Land at Climping, West Sussex

Transport Statement

i-Transport Ref: TW/BB/ITB16079-002B

Date: 23 August 2021

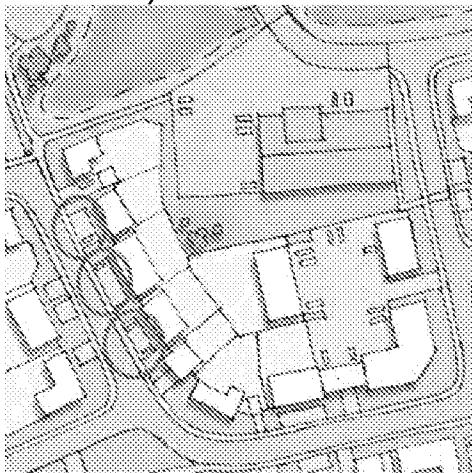
- *It should be confirmed if the road highlighted below has at least one footway abutting the carriageway unless there is a specific planning requirement/feature which requires a verge between the carriageway and footway.*

- *It is not clear from the plan if the areas circled in red below are parking spaces. If these are parking spaces are they perpendicular or parallel to the carriageway. Parallel parking would create safety issues as vehicles would be driving parallel on the footway.*

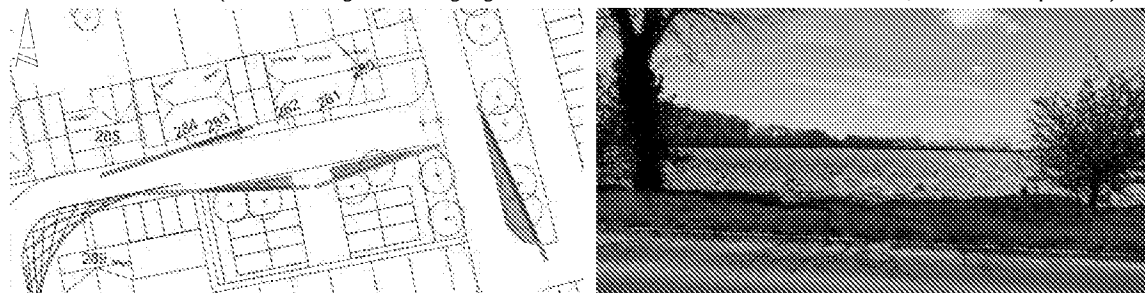
A.1	LOCAL ALIGNMENT
A.1.1	PROBLEM
Location:	Scheme
Summary:	Visibility extends across land assumed to be outside the proposed highway
Acc Type:	Sideswipes
The proposals associated with this Stage 1 Road Safety Audit, includes general carriageways with footways as well as shared surface areas that are to be provided within a residential development which accommodates a number of speed control bends. The scheme drawings provided with the Audit Brief, illustrate the provision of 17 metre forward visibility envelopes that are adequate for speeds of up to 15mph. The presence of speed control bends should ensure vehicular speeds are maintained low and that the achievable visibility is adequate. However, at some locations, the 17 metre envelopes passed across land that is assumed to be outside the public highway. Should vegetation be planted and permitted to grow within the areas, visibility to and from approaching vehicles could be limited and lead to sideswipe type collisions when opposing vehicles attempt to pass on a bend in the road.

RECOMMENDATION:	
It is recommended that a sufficient level of visibility is achievable at all times	
Location Plan: (NB: The image below highlights two locations where this item is relevant, more may be present) 	
DESIGN ORGANISATION RESPONSE provided by I-Transport on the 20th August 2021 following formal issue of this Stage 1 Road Safety Audit on the 18th August 2021.	
Agreed – a covenant will be placed on the affected properties requiring that any planting must be maintained below 600m to ensure the visibility envelopes can be achieved.	
AUDITOR'S VIEW OF DESIGN ORGANISATION RESPONSE dated 20th August 2021	
Confirmation that visibility will be maintained clear of obstructions, addresses the road safety concern at this stage.

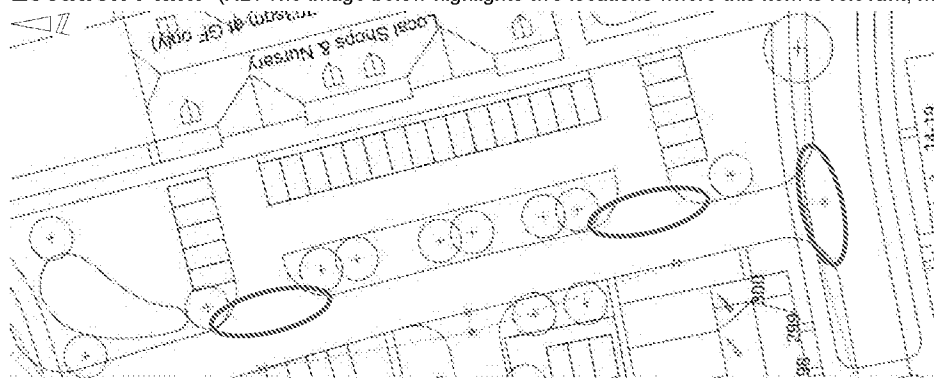
A.2	GENERAL
	<i>No Road Safety Concerns in GENERAL have been raised at this stage</i>
A.3	JUNCTIONS
A.3.1	PROBLEM
Location:	Scheme
Summary:	Visibility extends across land outside the proposed highway
Acc Type:	Vehicle side impact collisions
The proposals associated with this Stage 1 Road Safety Audit, includes general carriageways with footways as well as shared surface areas that are to be provided within a residential development of 300 dwellings that each accommodate off-street parking, be it within driveways or parking courts. The scheme drawings provided with the Audit Brief, illustrate that 25 metre visibility splays are achievable where carriageways meet in accordance with the stopping sight distance of approaching vehicles travelling at 20mph. The presence of speed control bends and traffic calming measures in the form of raised tables and shared surface areas should ensure vehicular speeds are maintained low and that the achievable visibility is adequate. However, the visibility splays illustrated at many of the driveways and entrances to the parking courts, to include in proximity to the local shops and nursery, pass over land that is assumed to be outside the public highway. Should vegetation be planted and permitted to grow within the areas, visibility to and from approaching vehicles could be limited which may lead to a vehicle attempting to exit a priority access when it is not safe to do so, into the path of an oncoming vehicle and lead to side impact collisions.

RECOMMENDATION:	
It is recommended that a sufficient level of visibility is achievable at all times	
Location Plan: (NB: The image below highlights two locations where this item is relevant, more are be present)

DESIGN ORGANISATION RESPONSE provided by I-Transport on the 20 th August 2021 following formal issue of this Stage 1 Road Safety Audit on the 18 th August 2021.	
Agreed – A covenant will be placed on the affected properties requiring that any planting must be maintained to 600mm or below to ensure that visibility splays can be achieve.	
AUDITOR'S VIEW OF DESIGN ORGANISATION RESPONSE dated 20th August 2021	
<i>Confirmation that visibility will be maintained clear of obstructions, addresses the road safety concern at this stage.</i>

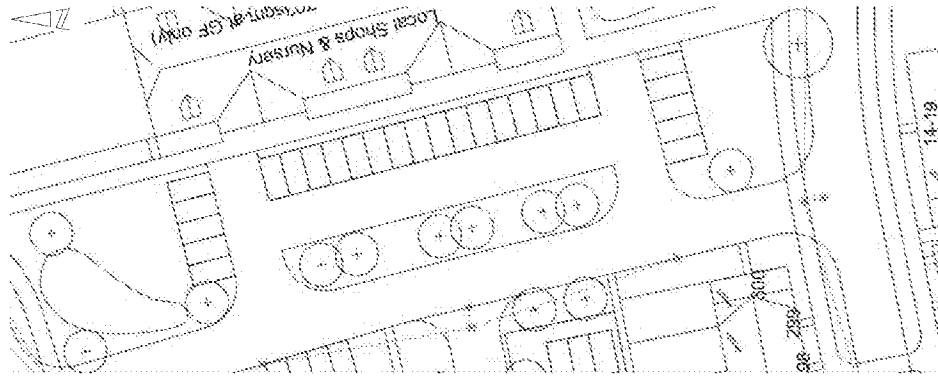
A.3.2	PROBLEM
Location:	Scheme
Summary:	Priority may not be clear to drivers approaching junctions
Acc Type:	Vehicle side impact collisions
The proposals associated with this Stage 1 Road Safety Audit, includes general carriageways with footways as well as shared surface areas with a number of junctions generated where traffic can continue in different directions. Vehicular speeds are expected to be low and priorities should be clear where road geometry and surface treatments change, however, drivers may approach the primary roads at inappropriate speeds and overshoot into the path of oncoming traffic or fail to give-way leading to side impact collisions	
RECOMMENDATION:	
It is recommended that road markings are provided where appropriate.	
Location Plan: (NB: The image below highlights two locations where this item is relevant, more are be present) 	
DESIGN ORGANISATION RESPONSE provided by i-Transport on the 20th August 2021 following formal issue of this Stage 1 Road Safety Audit on the 18th August 2021.

Agreed – Road markings will be provided at priority junctions with the primary roads and at the entrance to / exit from the parking facility associated with the proposed local shops and nursery	
AUDITOR'S VIEW OF DESIGN ORGANISATION RESPONSE dated 20th August 2021	
Confirmation that road markings will be provided where appropriate, addresses the road safety concern at this stage.	
A.4	WALKING CYCLING AND HORSE RIDING
A.4.1	PROBLEM
Location:	Scheme
Summary:	Pedestrians may not be seen during the hours of darkness
Acc Type:	Vehicle pedestrian collision
The scheme drawing provided with the Audit Brief, illustrate that the proposed on-site highway is to consist of 4.8 and 6 metre wide carriageways and shared surface areas. At this stage, the Audit Team is unaware if the proposals are to be subject to street lighting. Whilst vehicles are driven during the hours of darkness with head lights illuminated, drivers may not become aware of the presence of pedestrians at a safe distance leading to vehicle pedestrian collisions.

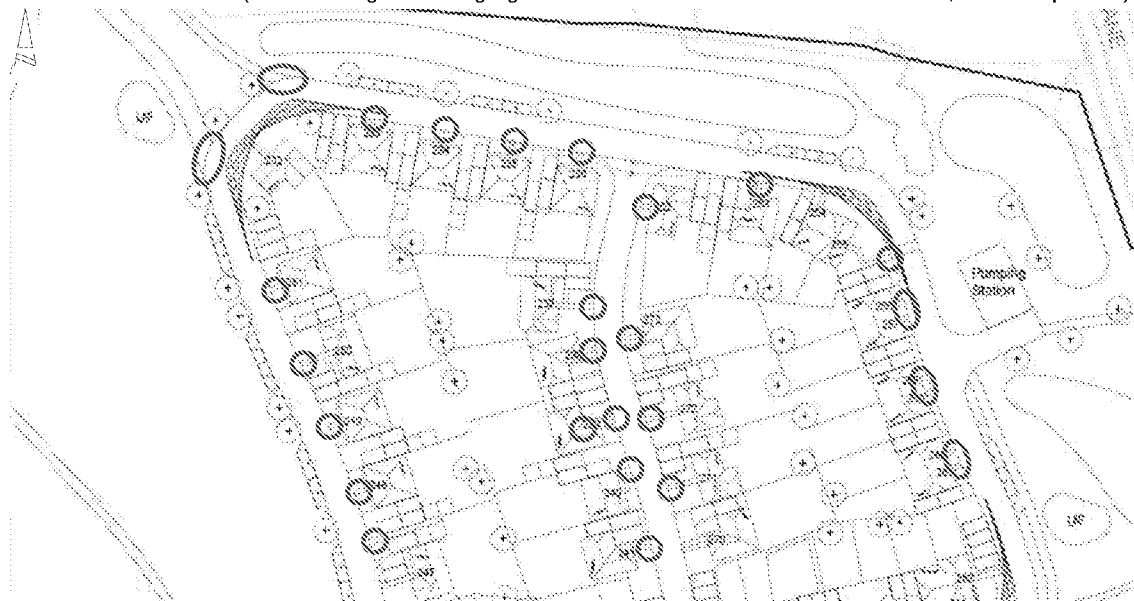
RECOMMENDATION:	
It is recommended that a level of street lighting is provided particularly in proximity to where pedestrians can be expected to cross or enter the carriageway and within the shared surface areas.	
Location Plan: (NB: The image below highlights two locations where this item is relevant, more are be present) 	
DESIGN ORGANISATION RESPONSE provided by I-Transport on the 20 th August 2021 following formal issue of this Stage 1 Road Safety Audit on the 18 th August 2021.	
Agreed - this will be dealt with at the detailed design stage.	
AUDITOR'S VIEW OF DESIGN ORGANISATION RESPONSE dated 20th August 2021	
Confirmation that this item will be considered during detail design, addresses the road safety concern raised at this stage.	
A.4.2	PROBLEM
Location:	Scheme
Summary:	Full height kerbs will be an obstruction to non-motorised users
Acc Type:	Trip / fall and personal injury, vehicle pedestrian collisions

The scheme drawing provided with the Audit Brief, identifies that the proposed development is to consist of general carriageways with footways as well as raised shared surface areas with direct accesses to pathways to properties and footpath / cyclepath links. At this stage no details have been provided to identify the proposed edge treatment around the shared surface areas. Kerbing in excess of 6mm is a trip hazard for pedestrians, those with perambulators, the mobility impaired and cyclists which could lead to falls and personal injury. Further, visually impaired pedestrians could enter a live carriageway into the path of a vehicle unaware leading to a vehicle pedestrian collision	
RECOMMENDATION:	
It is recommended that level access is provided along non-motorised user desire lines.

DESIGN ORGANISATION RESPONSE provided by i-Transport on the 20 th August 2021 following formal issue of this Stage 1 Road Safety Audit on the 18 th August 2021.	
Agreed - Desire lines will be assessed during the detail design of the scheme with dropped kerbs and tactile paving provided where necessary.	
AUDITOR'S VIEW OF DESIGN ORGANISATION RESPONSE dated 20th August 2021	
Confirmation that dropped kerbs and tactile paving will be provided, addresses the road safety concern raised at this stage.	
A.4.3	PROBLEM
Location:	Southern side of primary spine road
Summary:	Hedges could grow to limit visibility to and from a non-motorised user
Acc Type:	Vehicle pedestrian collisions
The proposals include the provision of numerous footpaths and cyclepaths as well as footways besides the proposed on-site carriageways. The site layout plan provided with the Audit Brief, illustrates what is believed to be hedges to the south of the primary spine road and either side of where the proposed footpaths meet the carriageway. No landscaping details have been provided at this stage, however, should the planting be permitted to grow higher than 600mm, there is a risk that non-motorised users attempting to cross the primary road and the driver of approaching vehicles, may not become aware of one another raising the risk of a non-motorised user entering the carriageway when it is not safe to do so, into the path of a vehicle leading to a vehicle pedestrian collision

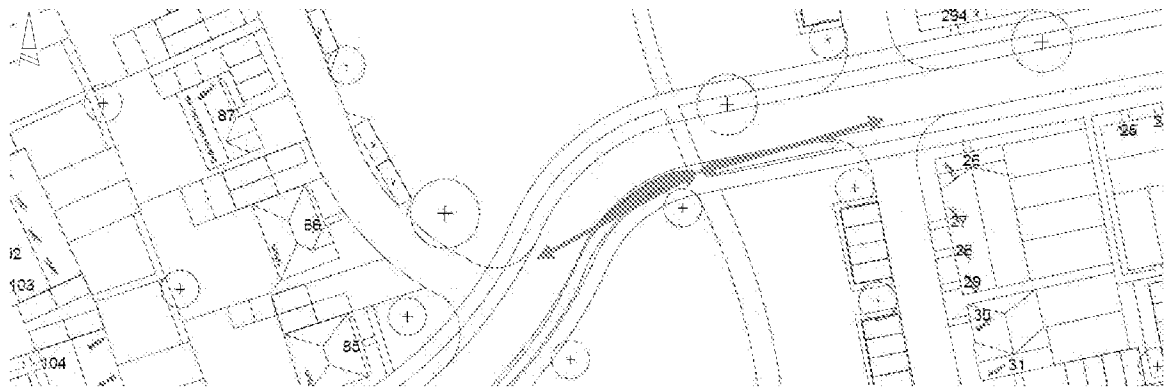
RECOMMENDATION:	
It is recommended that no foliage is planted within pedestrian visibility slays to ensure clear visibility is maintained at all times

Location Plan: 	
DESIGN ORGANISATION RESPONSE provided by i-Transport on the 20th August 2021 following formal issue of this Stage 1 Road Safety Audit on the 18th August 2021.	
Agreed -- this will be dealt with at the detailed design stage.	
AUDITOR'S VIEW OF DESIGN ORGANISATION RESPONSE dated 20th August 2021	
Confirmation that this road safety concern will be further considered during the detail design of the scheme, addresses the road safety concern raised at this stage.	
A.5	TRAFFIC SIGNS, CARRIAGEWAY MARKINGS AND LIGHTING
	No Road Safety Concerns regarding TRAFFIC SIGNS, CARRIAGEWAY MARKINGS AND LIGHTING have been raised at this stage
